## Product Change Notification

**1. ECR #:** 221400  
**Notification #:** 672

**3. Series:**  
• 240 - 240 ST JACK FOR COMPRESSION MOUNT

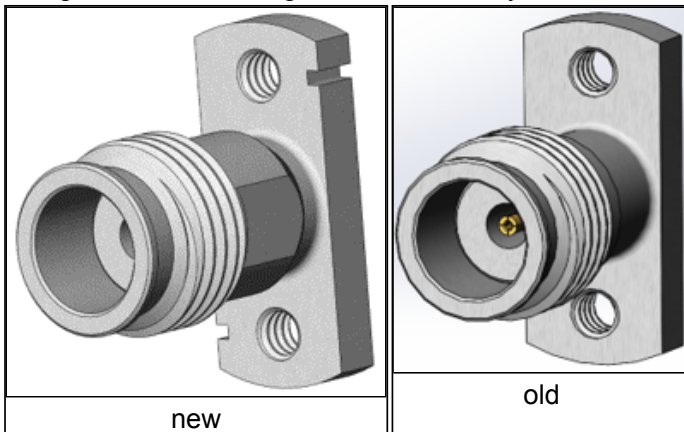
**5. Description of Change:**  
We added two grooves on our body for PCB mounting alignment and a flange for our custom wrench to prevent rotation.

**6. Method of Identifying Change**  
Two grooves and a flange on the new body

**7. Reason for Change:**  
For better alignment onto the PCB

**8. Impact of Change on Form, Fit, or Function:**  
• Form - Form change
